Mail Control Number 314735

NRC License Number 13-03284-02 for Reid Hospital & Health Care Services

Please allow this letter to serve as a response to your request for additional information concerning our recent license amendment submission. Our responses follow the same order as your information requests.

# FACILITIES & EQUIPMENT DIAGRAM

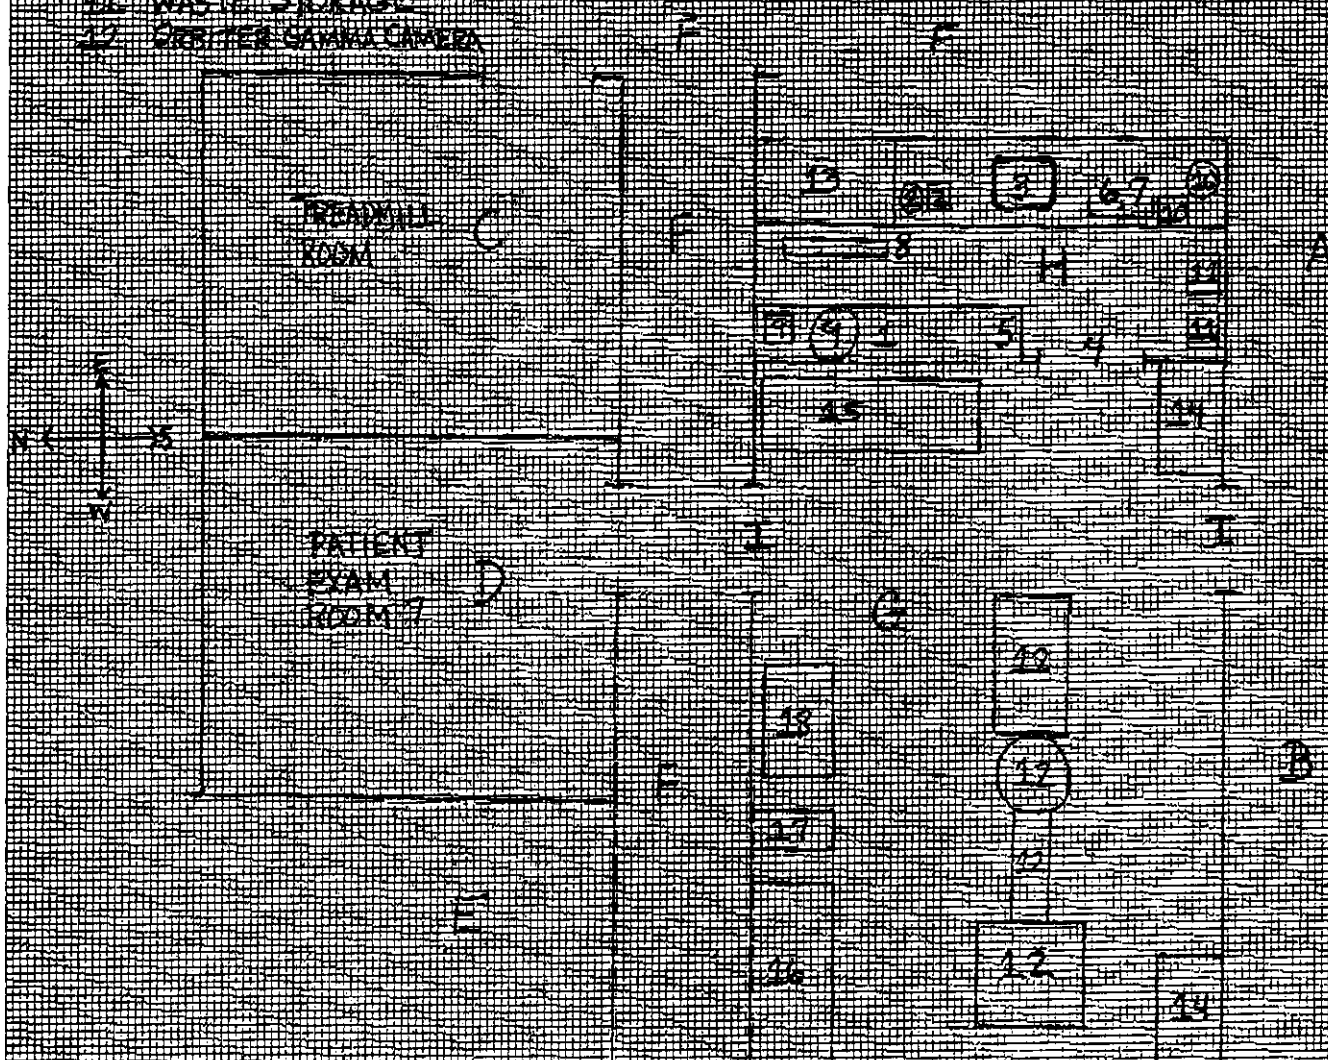
6. The use of radioactive materials at the proposed location of use will be limited to those regulated by 10 CFR 35.100 and 35.200. Please see the enclosed facility diagram.

FACILITIES & EQUIPMENT DIAGRAM

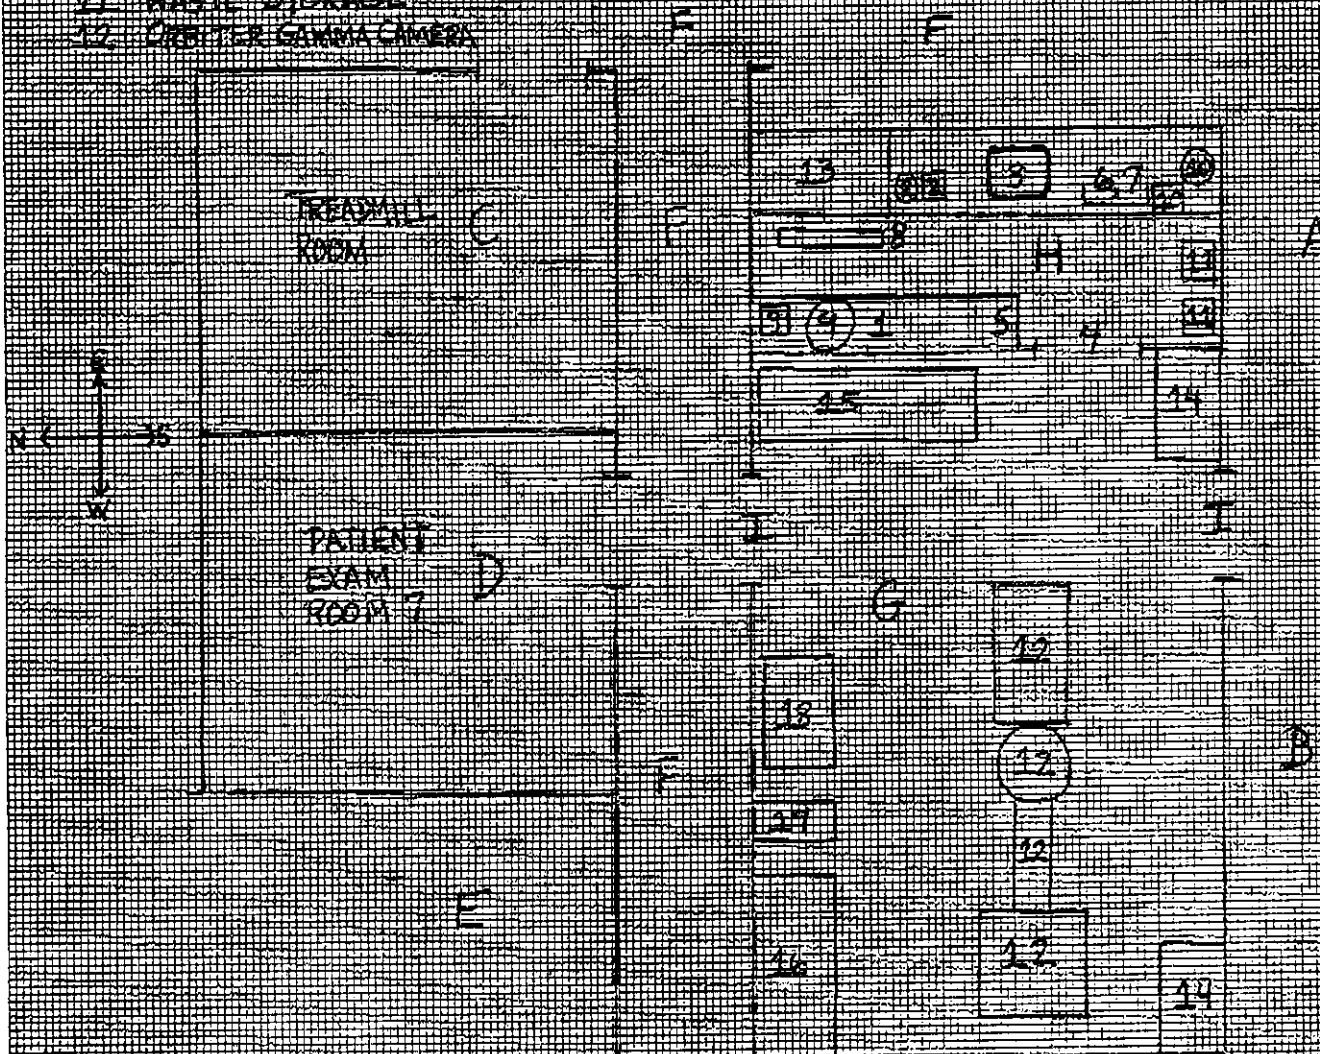
6. The use of radioactive materials at the proposed location of use will be limited to those regulated by 10 CFR 35.100 and 35.200. Please see the enclosed facility diagram.

1. Any delegate or outside consultant will report any findings or issues to the Radiation Safety Officer. The findings or issues will be reported to the Radiation Safety Officer verbally or in writing, as the situation requires. Any issues or findings that need to be brought to the attention of the Radiation Safety Committee will be done so.
2. The staff at the proposed location of use will contact the Radiation Safety Officer by phone. The staff will be provided with both the hospital phone number and the home phone number of the Radiation Safety Officer.
3. The doors to the Nuclear Camera Room are labeled "Nuclear". There is no room number.

The door to the Hot Lab is labeled "Caution Radioactive Materials" and has the radiation symbol. There is no room number.

The treadmill room does not have a room number.
